The City of New York

The City of New York's Comments on the Proposed Plan for the Gowanus Canal Superfund Site

April 26, 2013

Figure 12-1

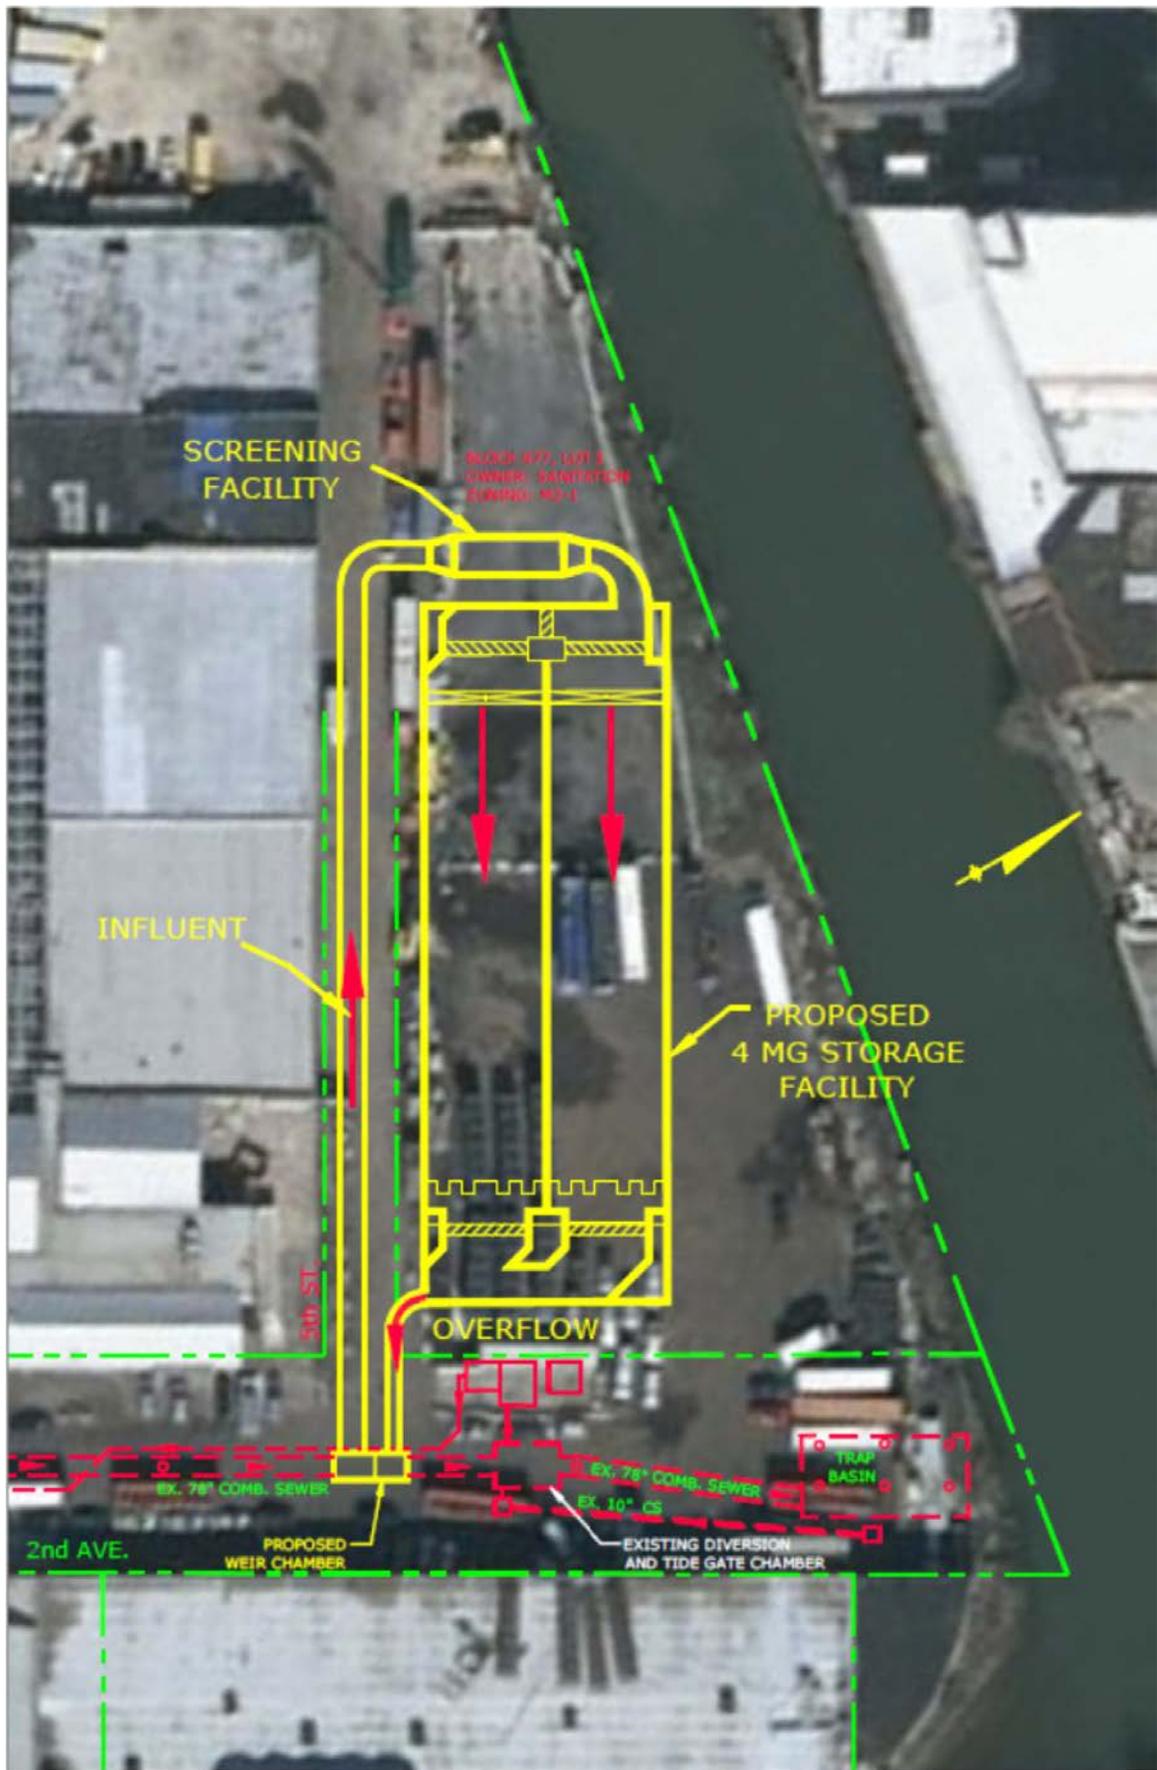
Figure 12-1 presents the DEP’s LTCP CSO tank cost curves for design and construction of CSO storage tanks. These cost curves were developed based on the DEP’s experience building tanks in New York City and more accurately reflect costs in the City as compared to the estimates presented in the FS Addendum for several reasons.

The table below shows the estimated costs of constructing the two tanks using the LTCP cost curve, with a total cost for the two tanks of \$357 million. EPA estimated that the two tanks would cost \$77.7 million to construct: \$31.3 million for a 4-MG CSO storage tank for outfall OH-007 and \$46.4 million for an 8-MG CSO storage tank for outfall RH-034 (FS Addendum, Technical memorandum *CSO Storage Tanks Draft Cost Estimates, Gowanus Canal, Brooklyn, New York* (“Tank Cost Estimates”)) (refer to Figure 12-1).

The costs for constructed projects included on Figure 12-1 were converted to September 2012 dollars so as to be in the same time frame as the costs provided in the FS Addendum. For example, for Alley Creek costs for ER-AC1 were escalated from August 2002 to September 2012; costs for ER-AC2 were escalated from August 2006 to September 2012; and costs for ER-AC3 were escalated from July 2007 to September 2012, using the escalation methodology in the DEP CSO Long Term Control Plan project.

DEP understands that cost estimates are variable but based on DEP's actual final costs of building CSO storage tanks as detailed on Figure 12-1, DEP estimates that it would cost approximately \$357 million to construct a 4M-gallon tank at OH-007 and an 8M-gallon tank at RH-034. In other words, construction of both tanks is likely to cost over four times EPA's estimate of \$77.7 million. Because DEP's estimate of \$357 million is based on its actual experience building tanks in New York City, DEP believes they are more accurate than the estimates presented in the FS Addendum.
